# UNITED STATES PATENT AND TRADEMARK OFFICE

APPLICATION NO.	FILING DATE	FIRST NAMED INVENTOR	ATTORNEY DOCKET NO.	CONFIRMATION NO.
10/725,133	12/01/2003	Chang-Hun Lee	8071-42 (OPP 030497US)	2641
22150	7590	10/25/2006	EXAMINER	
F. CHAU & ASSOCIATES, LLC 130 WOODBURY ROAD WOODBURY, NY 11797			CHEN, WEN YING PATTY	
			ART UNIT	PAPER NUMBER
			2871

<b>Office Action Summary</b>	Application No.	Applicant(s)	
	10/725,133	LEE ET AL.	
	Examiner	Art Unit	
	W. Patty Chen	2871

## **DETAILED ACTION**

*FIG. 21*

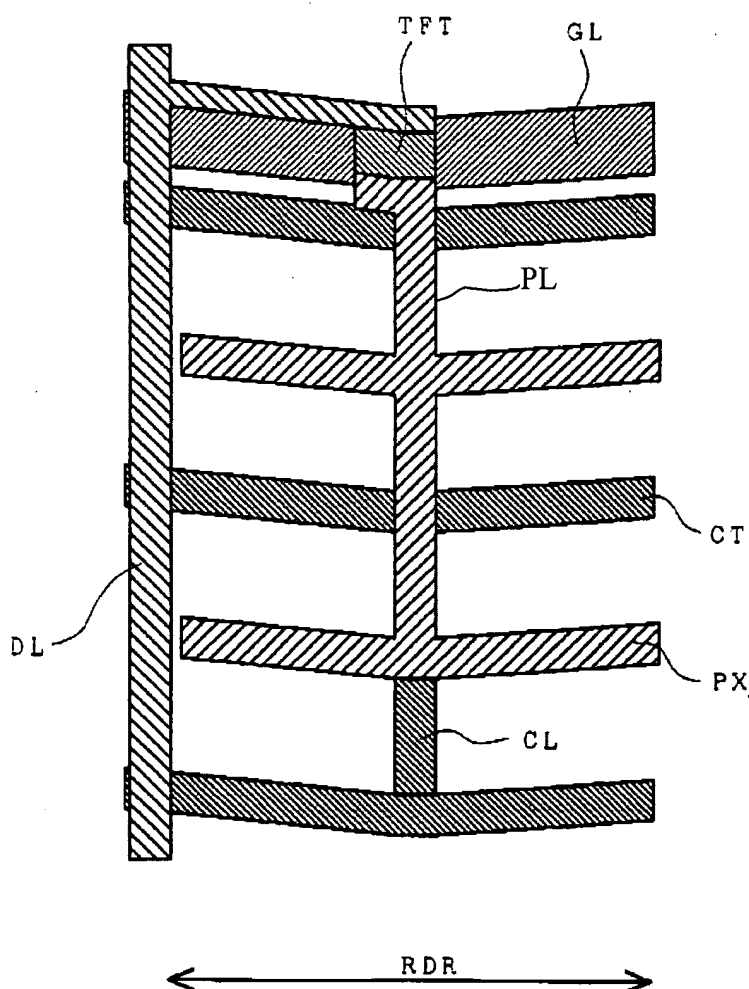
Claim 38 is rejected under 35 U.S.C. 102(b) as being anticipated by Ohta et al. (US 6266116).

Ohta et al. disclose in Figure 21 a liquid crystal display, comprising:

a gate line (element GL) formed on the substrate and extending in a first direction;

a data line (element DL) intersecting the first direction;

a first pixel electrode (element PX) formed in a pixel area defined by intersections of the gate line and the data line, the first pixel electrode formed substantially parallel to the gate line;

a pixel signal line (element PL, as shown in the figure below) connected to the pixel electrode;

a switching element (element TFT) connected to the gate line, the data line, and the pixel signal line;

a first common electrode (element CT) formed in the pixel area parallel to the first pixel electrode;

a common signal line (element CL) formed in the pixel area connected to the common electrode;

a first capacitor electrode (a middle portion of the pixel signal line overlapped by the common signal line) formed in the pixel area connected to the pixel signal line;

a second capacitor electrode (a middle portion of the common signal line overlapped by the pixel signal line) formed in the pixel area connected to the common signal line;

a second pixel electrode (element PX) formed in the pixel area opposite to the first pixel electrode and connected to the pixel signal line; and

a second common electrode (element CT) formed in the pixel area, the second common electrode opposite to the first common electrode and connected to the common signal line,

wherein the pixel signal line overlaps the common signal line (as shown in the figure).

With respect to claim 1 (Amended): Ohta et al. disclose in Figure 21 a liquid crystal display, comprising:

Ohta et al. fail to disclose that the distance between the common signal line and the data line is shorter than the distance between the pixel signal line and the data line.

However, Lee et al. teach in Figure 3 and Column 8 lines 11-17 a common signal line (element 23a-2) and a pixel signal line (element 27a) wherein the pixel signal line is formed as to have a width equal to or less than the common signal line, thus, since the common signal line has a width greater than the pixel signal line, hence, the distance between the common signal line and the data line is shorter than the distance between the pixel signal line and the data line.

Therefore, it would have been obvious to one of ordinary skill in the art at the time the invention was made to construct a liquid crystal display as taught by Ohta et al. wherein the common signal line is formed wider than the pixel signal line as taught by Lee et al., so that the distance between the common signal line and the data line is shorter than the distance between the pixel signal line and the data line, since Lee et al. teach that the aperture ratio and the transmittance of the display device can consequently be improved (Column 10, lines 55-62).

As to claim 2: Ohta et al. further disclose in Figure 21 that the pixel signal line (element PL, as shown in the figure above) overlaps the common signal line (element CL).

As to claim 3: Ohta et al. further disclose in Figure 21 that the common signal line (element CL) is parallel to the data line (element DL).

As to claim 5: Ohta et al. further disclose in Figure 21 that the gate line (element GL) bends at a positive or negative angle with respect to the perpendicular direction of the data line (element DL).
